California Regional Water Quality Control Board Santa Ana Region

ERRATA SHEET

CHANGES TO TENTATIVE ORDER NO. R8-2011-0046

**WASTE DISCHARGE REQUIREMENTS
FOR
POSEIDON RESOURCES (SURFSIDE) L.L.C.
HUNTINGTON BEACH DESALINATION FACILITY**

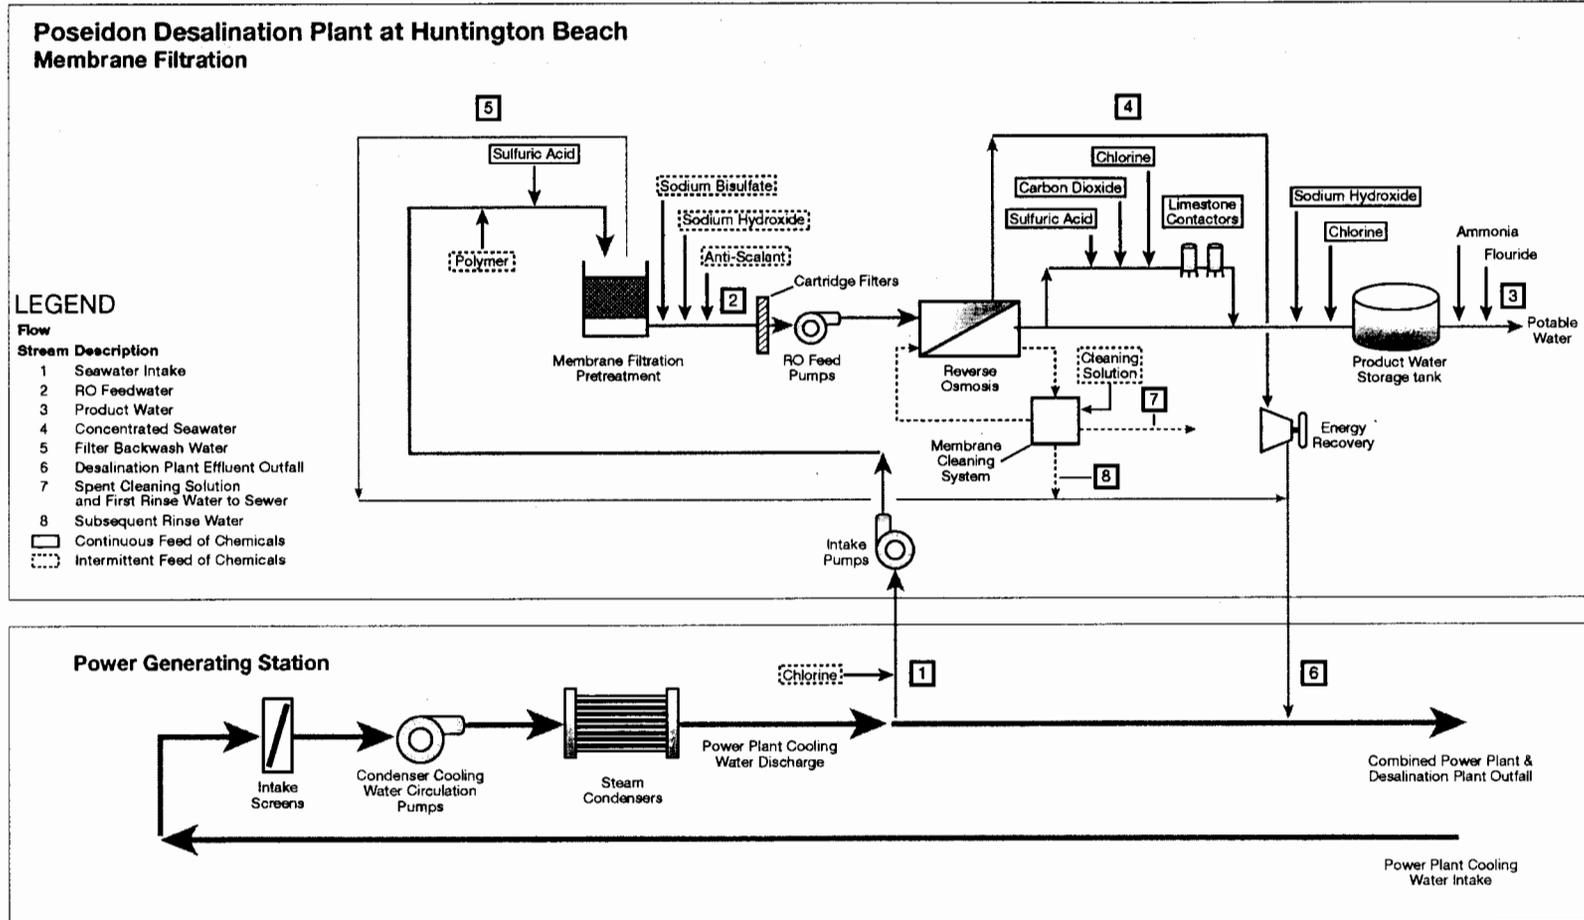
5. Modify the second paragraph on page F-32 of Attachment F- Fact Sheet, as follows:

If the Discharger submits a Report of Waste Discharge for approval of its long-term, stand-alone operations, the Regional Board will consider whether, by continuing the maintenance of AES's existing 66.8-acre tidal wetlands mitigation program, ~~The Regional Water Board finds that the Facility's long-term stand-alone operational scenario is in compliance with the mitigation requirements of Section 13142.5(b).~~
